**SITE PLAN REVIEW SHEET
ENVIRONMENTAL VARIANCE REQUEST ONLY**

CASE: SP-2019-0561C

PROJECT NAME: Koenig Lane Commercial

Staff Findings of Fact
Variance to LDC 25-8-261

PROPOSED DRAINAGE AREA MAP

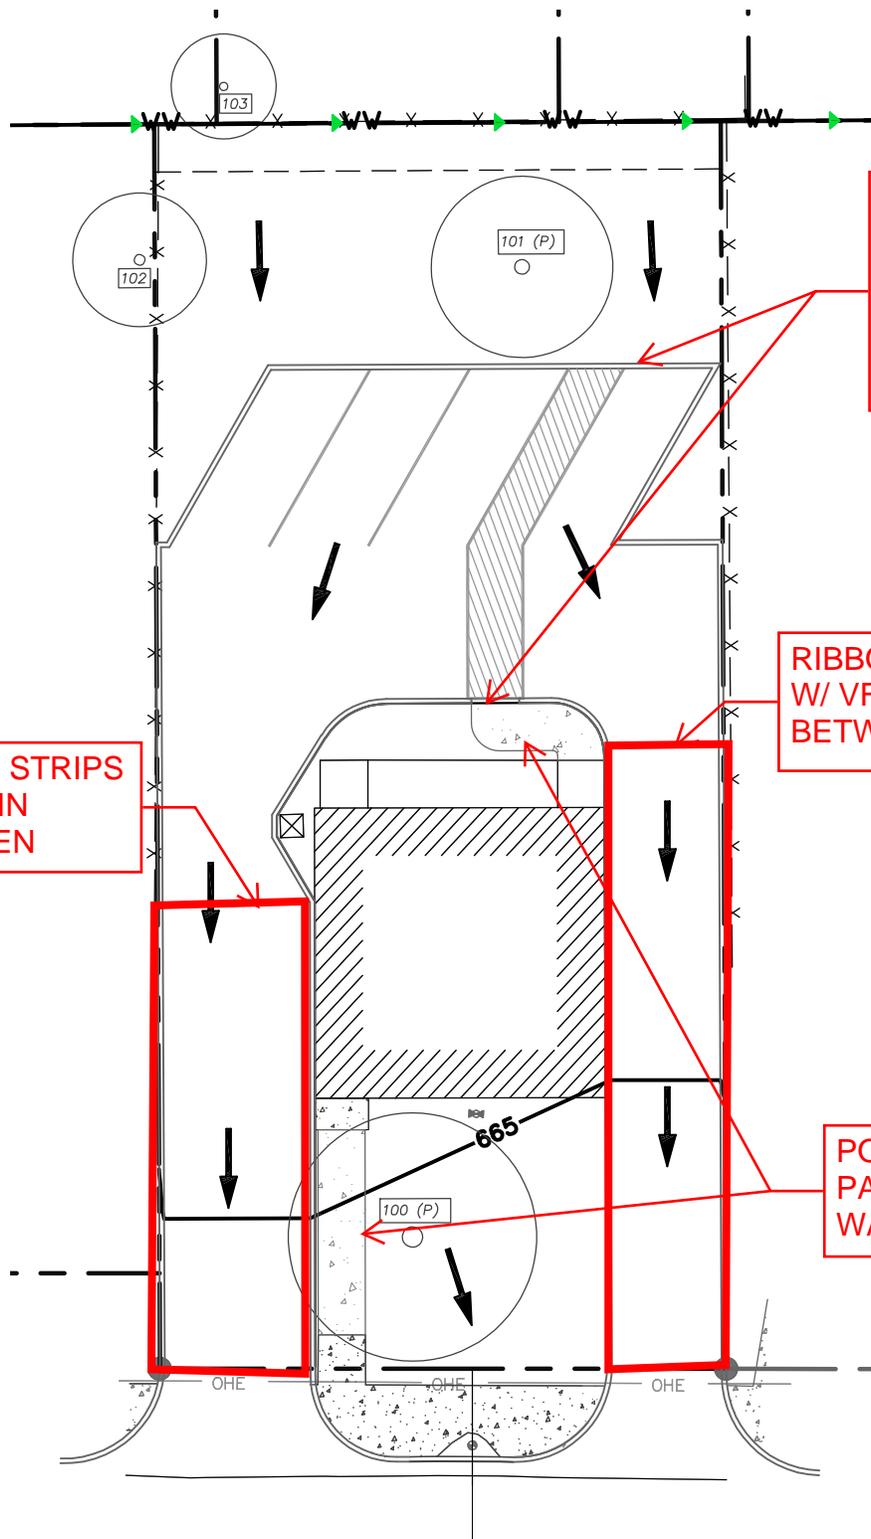
impervious cover, on-site water quality is not a requirement. Additionally, the applicant is reducing the overall proposed impervious cover on the property by providing “ribbon strips” for the driveway and porous concrete for all pedestrian walkways (page 16, variance packet). These two methods result in a total proposed impervious cover amount of 55%, where as much as 70% is allowed.

Yes/No [summary of basis for determination] The applicant has provided multiple ways of added water quality protection which includes Vegetative Filter Strips along the areas in sheet flow in conjunction with Ribbon curbs, Ribbon Strips in the driveways, and Porous Pavement in the walkable areas. The Proposed Impervious Cover has decreased from 67% to 55% with the added water quality controls.

Provide ribbon strips in the drive aisle, provide vegetative filter strips throughout the property to capture and treat stormwater runoff, and provide porous concrete for pedestrian paths to reduce overall impervious cover and promote more infiltration on site.
